L-2010-033

C-200, OFFSITE DOSE CALCULATION MANUAL REVISION 32  
(230 PAGES)

C-200, OFFSITE DOSE CALCULATION MANUAL REVISIONS 31B  
MARKED UP PAGES (5 PAGES)

Title: **OFFSITE DOSE CALCULATION MANUAL (ODCM)**

**FIGURE 1-3**  
**RADIOLOGICAL ENVIRONMENTAL SAMPLING LOCATIONS IN SUPPORT OF THE**  
**INDUSTRY INITIATIVE**  
 (Page 1 of 1)

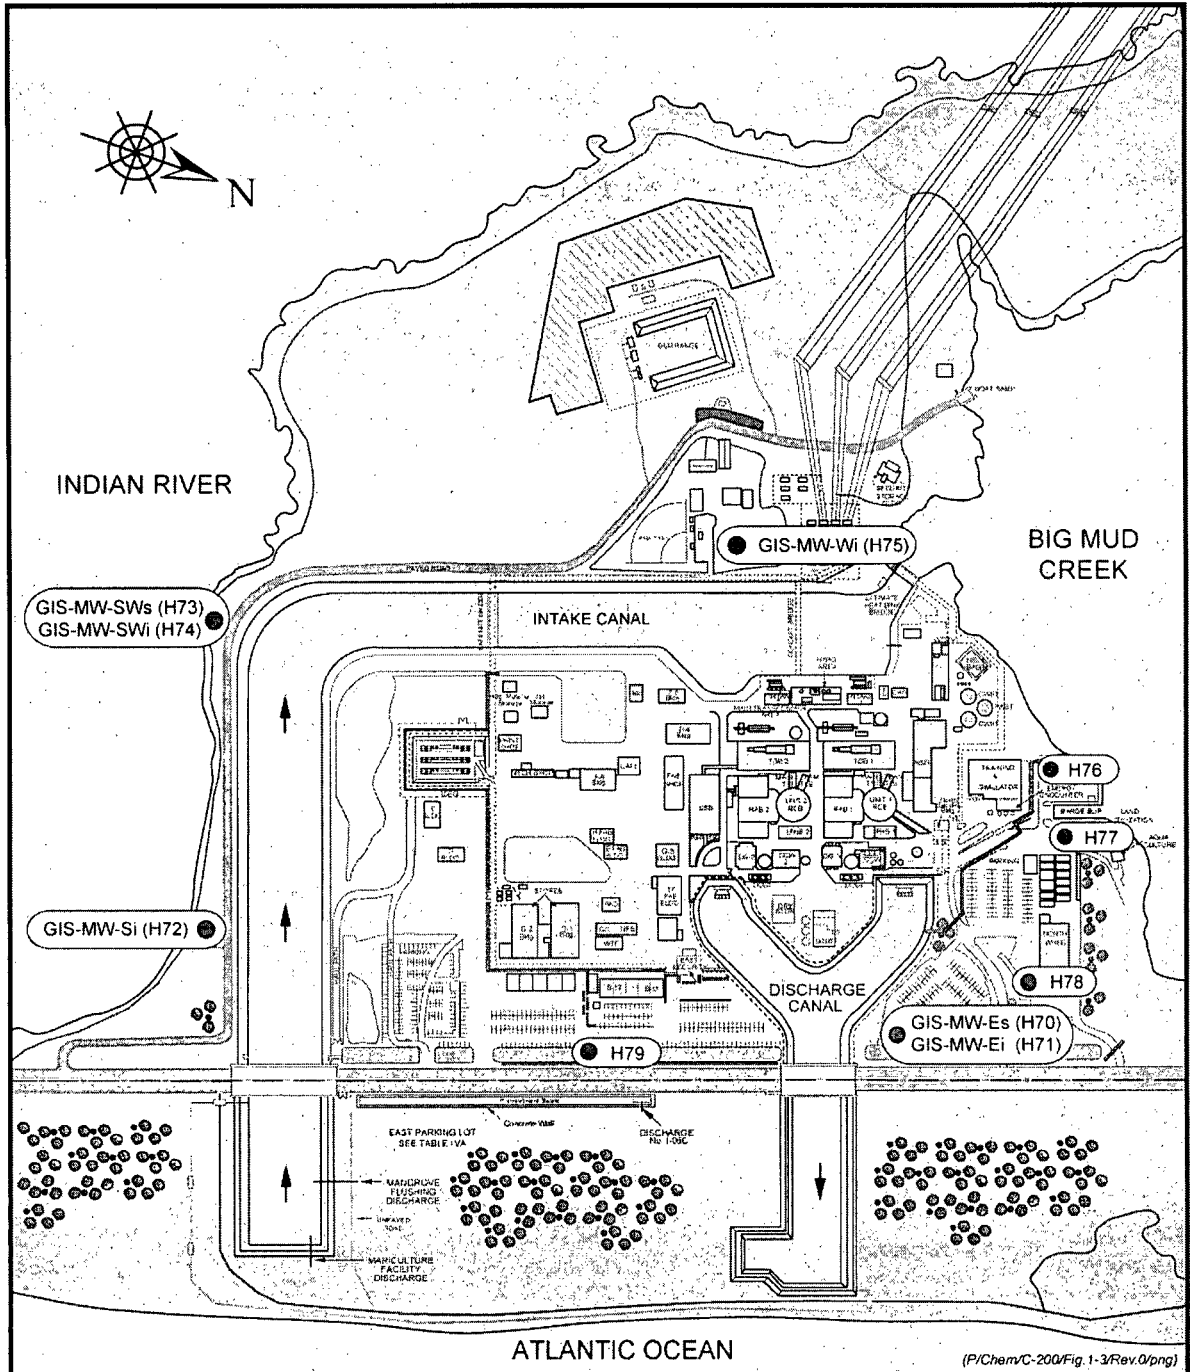
**Revision 32** - Incorporated PCR 09-2349 to add four Site Boundary Groundwater Wells to the remp. (Author: Bruce Vogel)
